**CHARTER TOWNSHIP OF VAN BUREN**  
**REVISED PLANNING COMMISSION AGENDA**  
**Wednesday, March 23, 2022 – 7:30 PM**  
**Van Buren Township Hall**  
**46425 Tyler Road**

**CASE 20-025 – DTE MODULAR RESTROOM ADDITION**

TO: Van Buren Township Planning Commission  
FROM: Dan Power– Director of Planning and Economic Development  
RE: Case 20-025 - DTE Modular Restroom Addition  
DATE: March 22, 2022

**Subject: VBT-20-025; DTE Energy Trailer Addition/8001 Haggerty Road; Site Plan Review #4;  
Revised plans not dated; recd. By Township on 3/2/2022.**

**A2**  
1  
ELEVATION

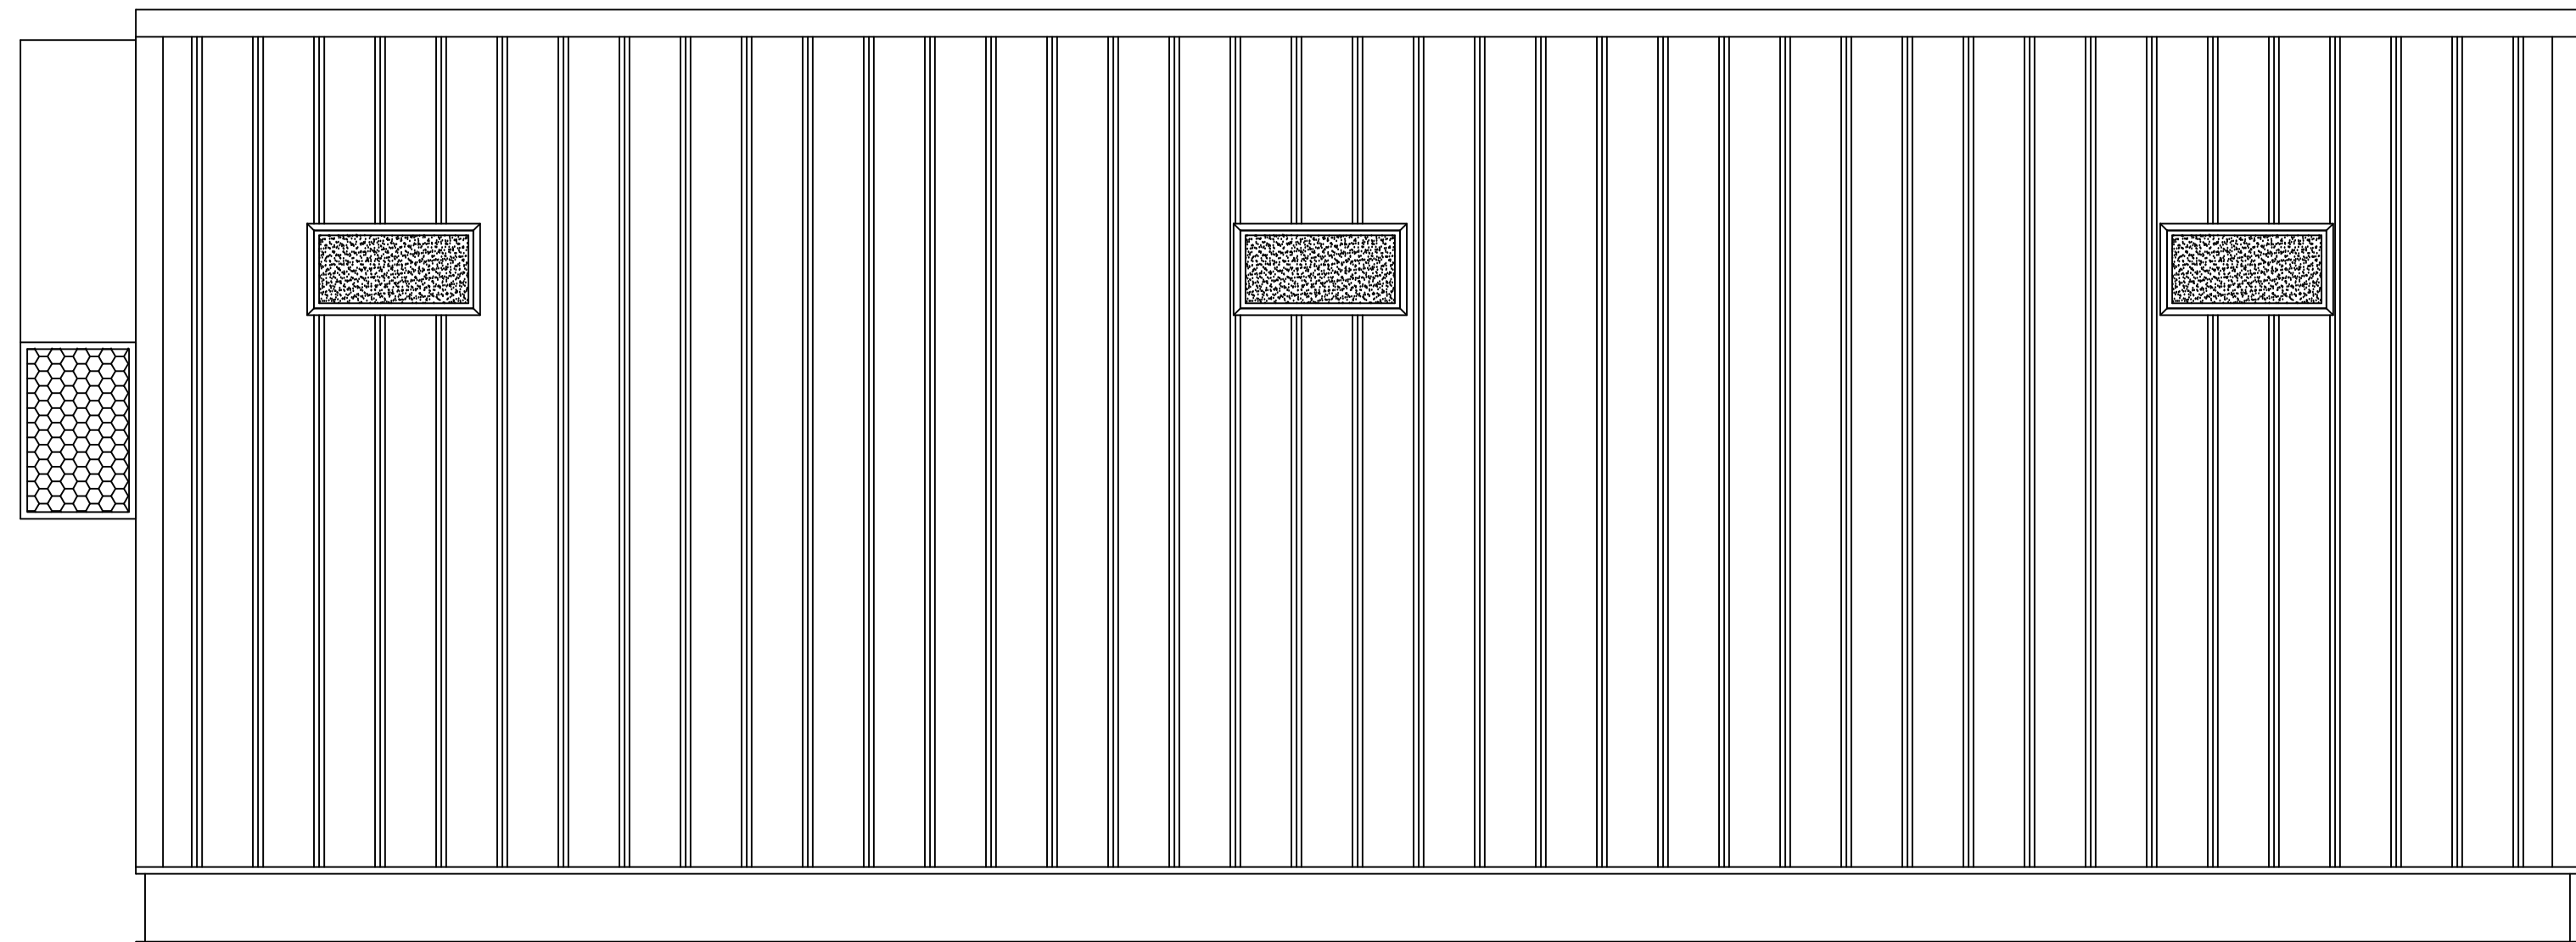
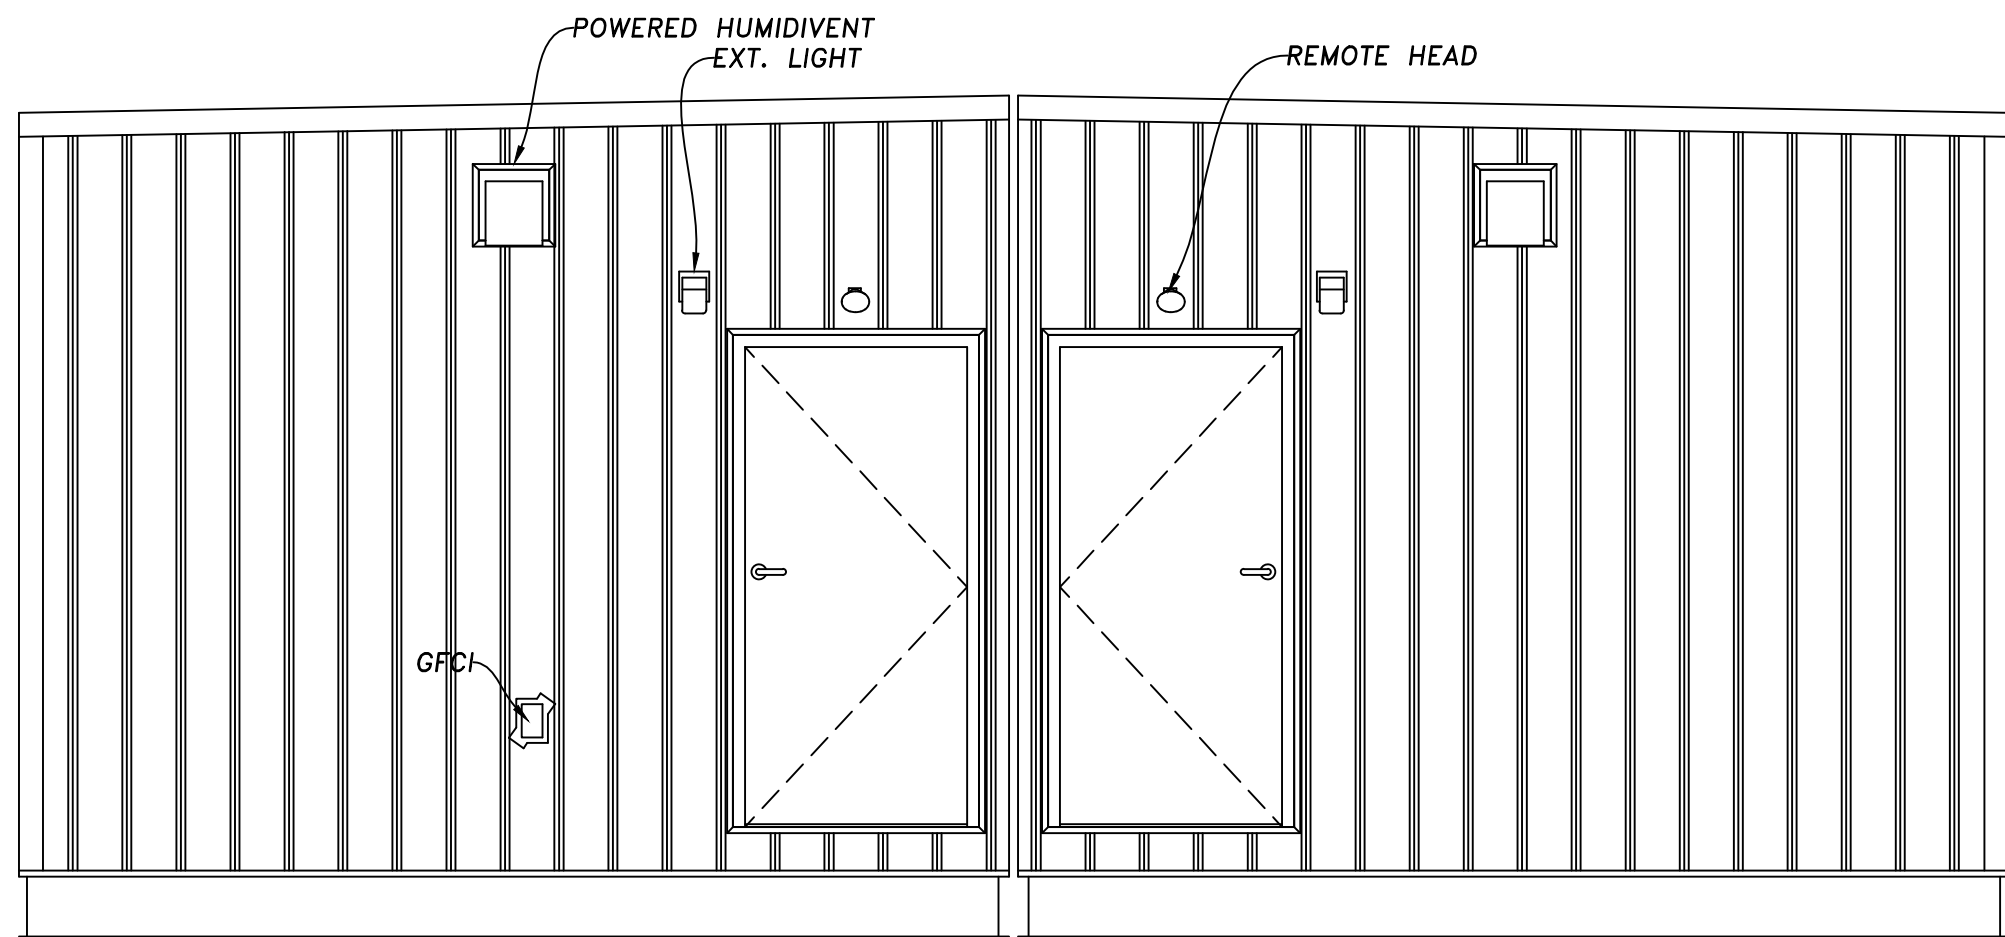
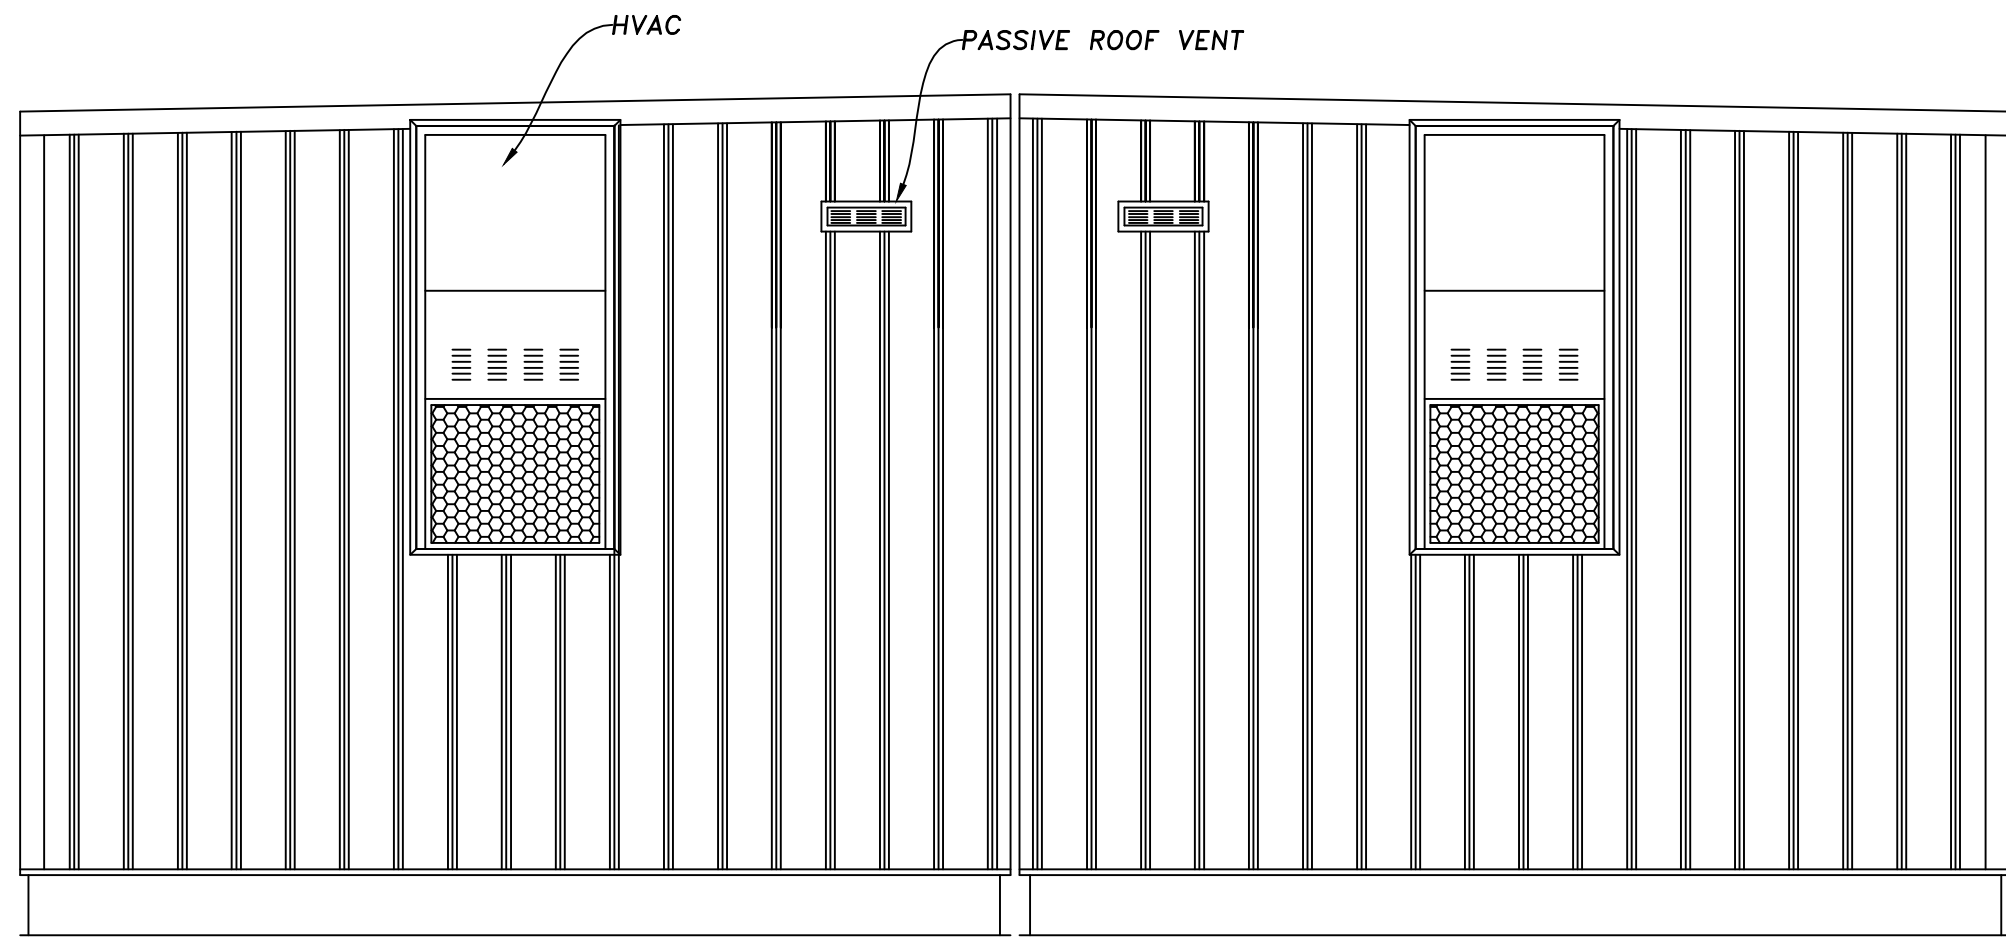
11. **Architecture and Building Details.** The applicant has submitted proposed elevations for the addition and trailer. The addition is to be constructed of masonry block, while the trailer is constructed of standing seam metal panels. The previous plan noted that the trailer will have a 28-guage vertical ribbed steel skirt to cover up the frame and provide a more aesthetic appearance. The applicant even described it in conversations:

however, the elevations submitted at this time do not identify a skirt. The elevations are shown with a steel perimeter frame. We recommend the applicant present a colored rendering of the proposed trailer with/without skirt, in order to ensure that it does not appear like a temporary add-on to the building and is in fact and integral feature of the main building. Any detail must go down to grade and support posts for the trailer should not be visible.
